Addendum 01

Project:	M&T Bank Stadium HVAC Controls, Lighting Controls and Submetering Systems Improvements	Date:	April 7, 2021
Subject:	Addendum 01	BKM Project No:	20092.01

The proposed additions, deletions, or modifications to the Bid Documents, dated February 12, 2021, are as follows:
Incorporate clouded revisions identified by a Delta 1, dated 04/02/2021.

HVU-11, 12, & 13 AND SEF-3 & 4 CONTROL

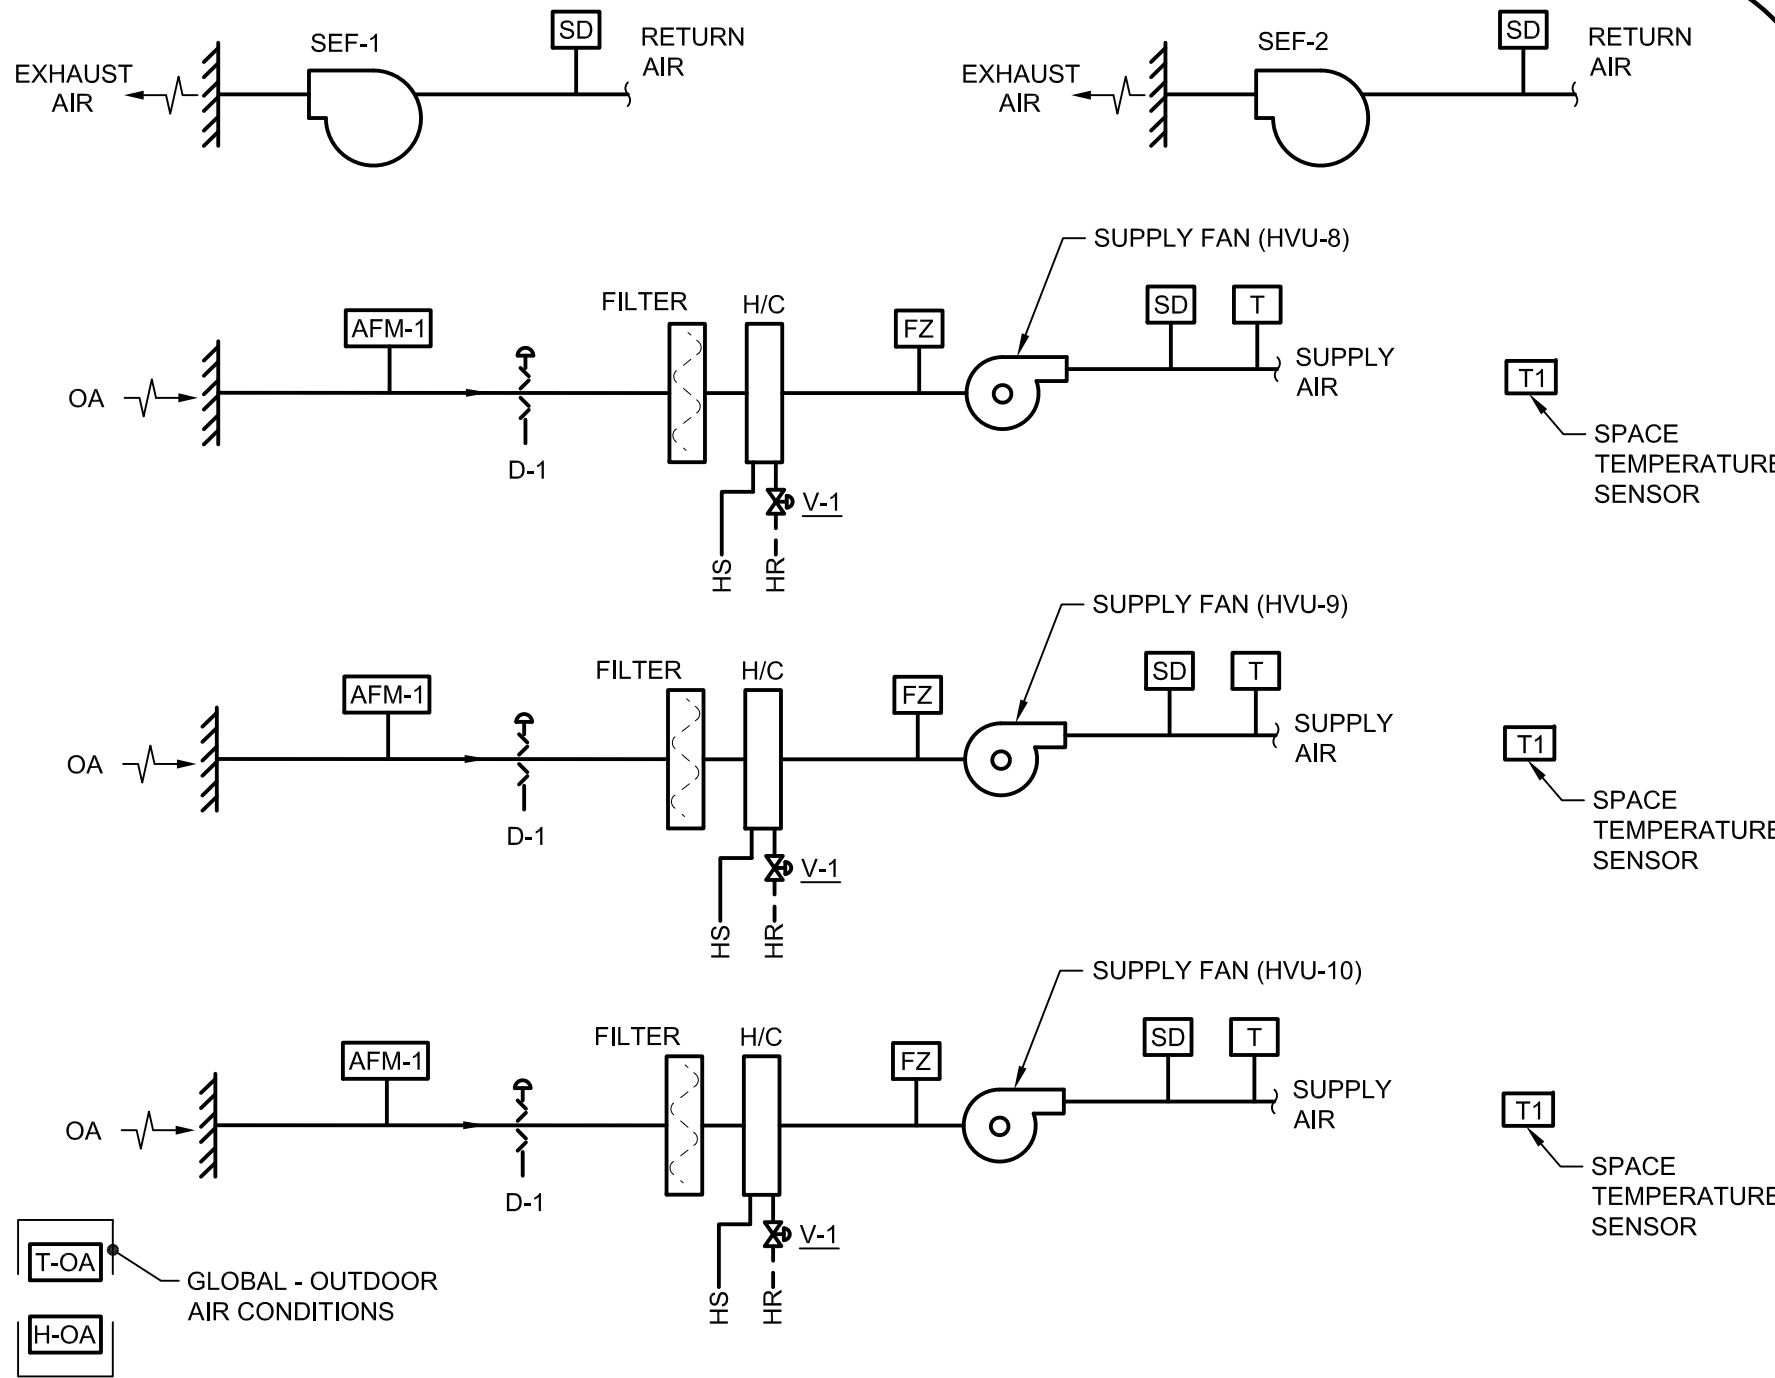
1. HVU-8, 9, &10 and SEF-1 & 2 Control modified as follows:
 - a. Exhaust fans shall remain de-energized in both "Occupied Heating" and "Unoccupied" modes.
2. HVU-11, 12, &13 and SEF-3 & 4 Control modified as follows:
 - a. Exhaust fans shall remain de-energized in both "Occupied Heating" and "Unoccupied" modes.
3. Global Outside Air Conditions (Multiple Sensors) Control modified as follows:
 - a. Removed OA sensor for Generator Plant.
 - b. Identified associated "fail to" sensors in case of OA sensor failure.
 - c. Indicated OA sensors shall be installed at the AHU louvers in an accessible location.

FIELD HEATING SYSTEM CONTROL

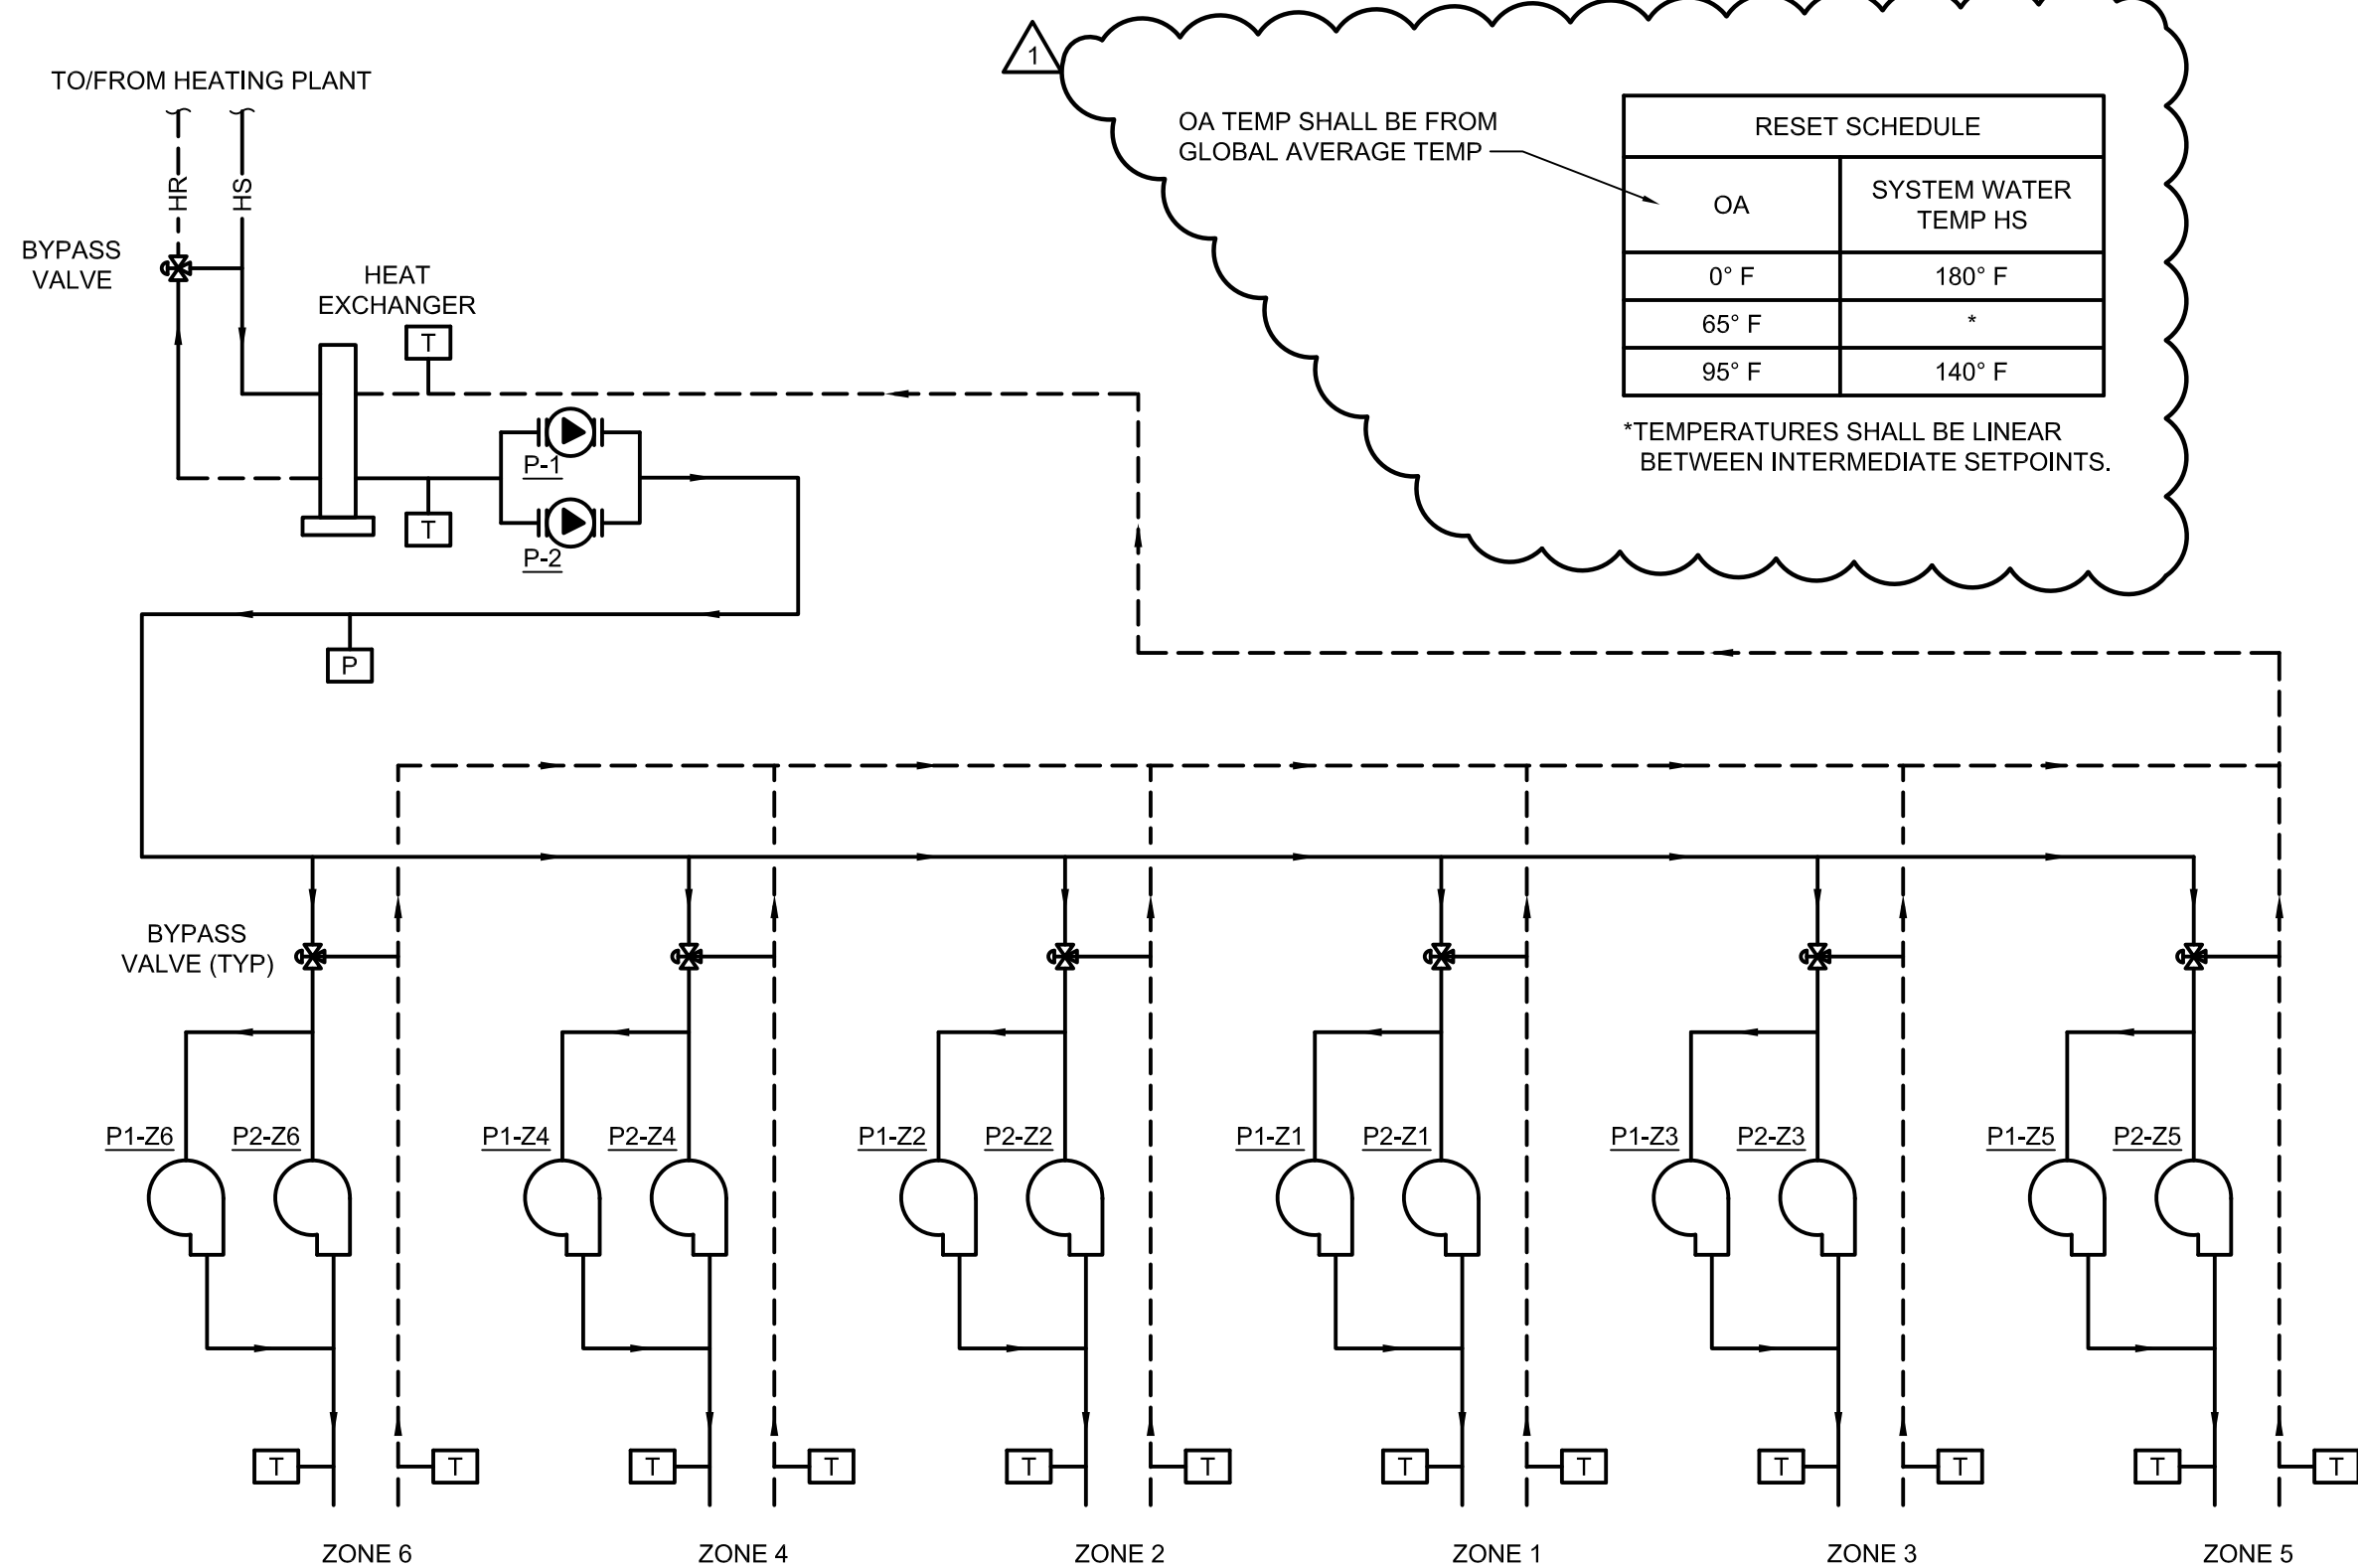
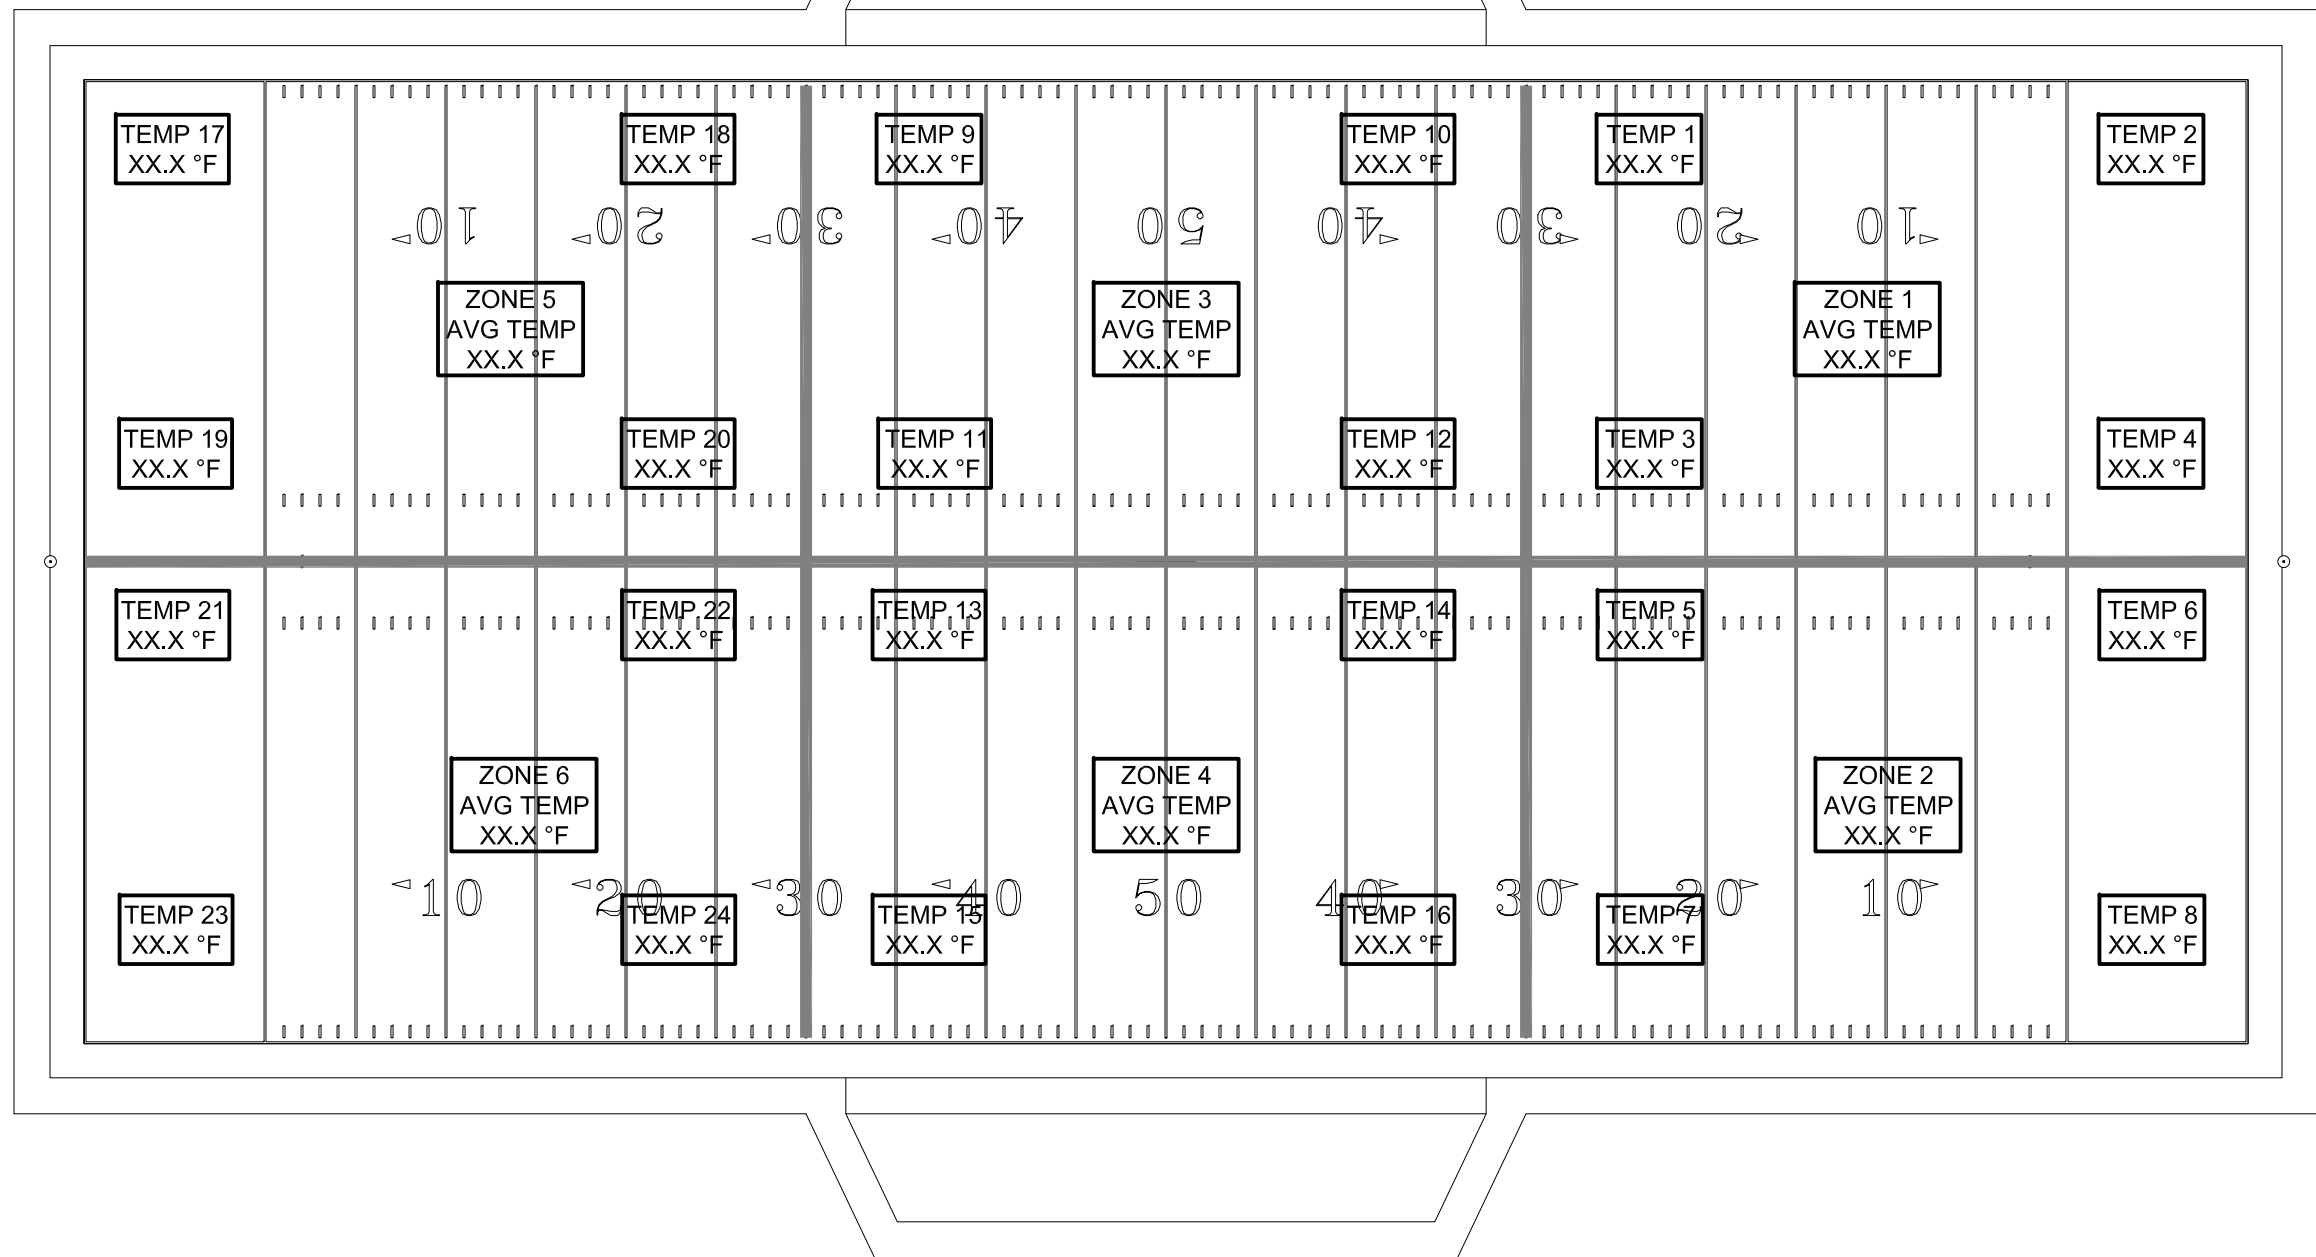
Drawing M4.27 – Automatic Temperature Controls

1. Raven's Offices Relief Fans Control modified as follows:
 - a. Noted that these fans only operate during "Executive" and "Full" scheduled modes.
2. Field Heating System Control modified as follows:
 - a. Added, System shall be "enabled" to operate.
 - b. Added a Reset Schedule for 180F to 140F (per MSA's comments on current operation)
 - c. Noted that the system shall maintain a field temperature of 50F.
 - d. Revised SOO language to match record Control Sequence.
